Technical Bulletin

Model(s)
32WL66P, 37WL66P, 42WL66P, 32WLG66, 32WLT66, 37WLG66, 37WLT66, 42WLG66, 42WLT66
Symptom
Subject: LVDS lead wire dressing
Cause
LVDS lead wire with a conductive tape should be dressed to the chassis GND with lead wire clamper after servicing to meet EMC requirement.
Refer to the picture for actual wiring dressing.
Note: The picture for the lead wire dressing shows some of representative model only. Follow the actual model original lead wire dressing.
Cure:

42WL66C

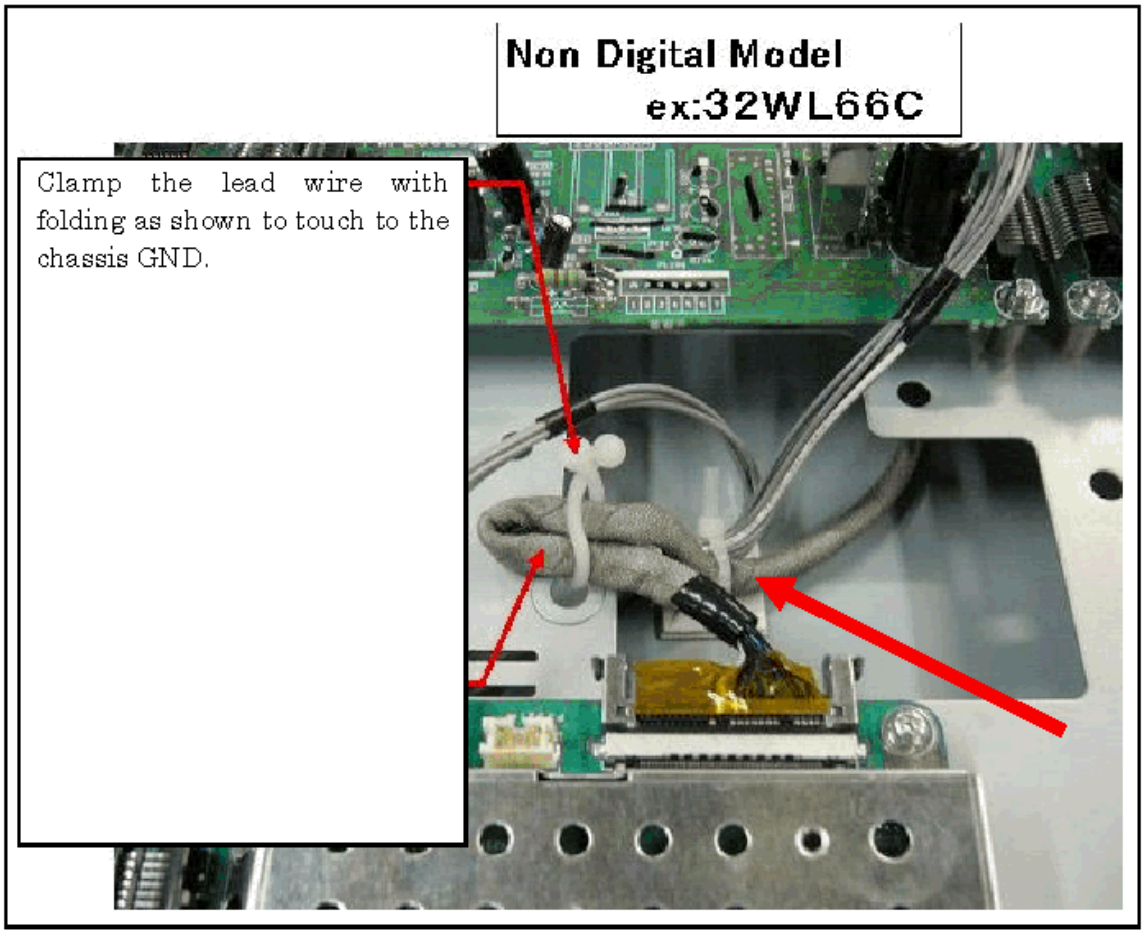
Clamp the lead wire to touch to the chassis GND.

Digital Model
ex:32WLT66

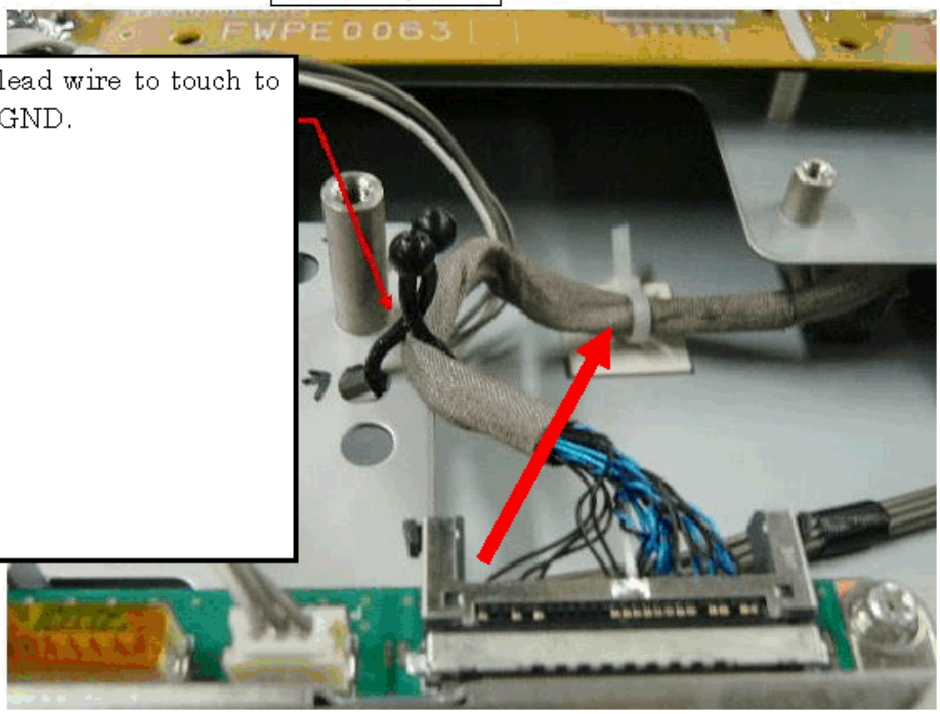
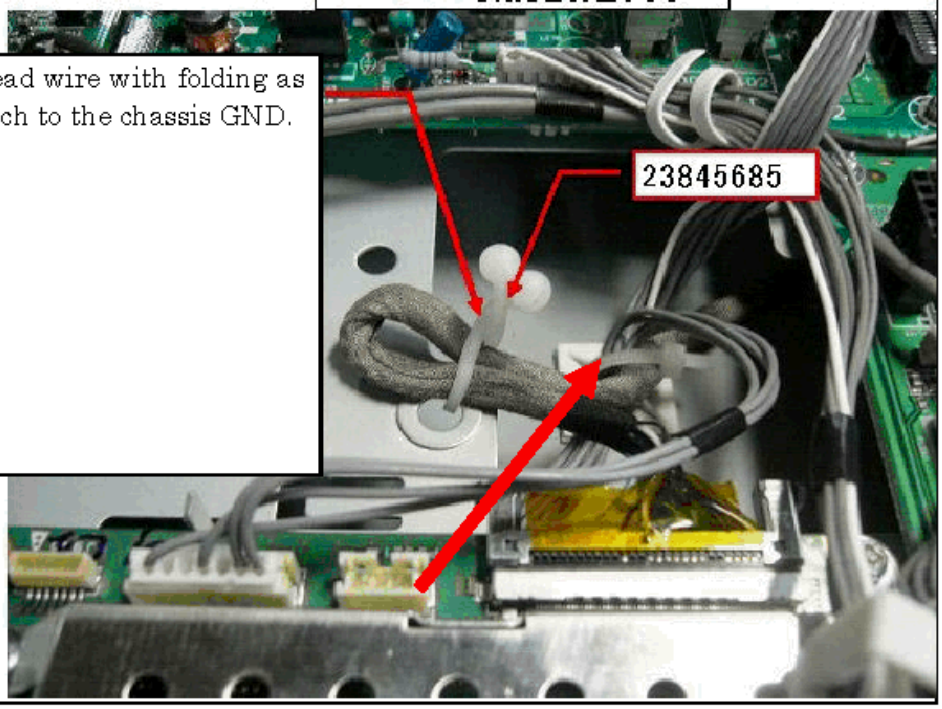
Clamp the lead wire with folding as shown to touch to the chassis GND.
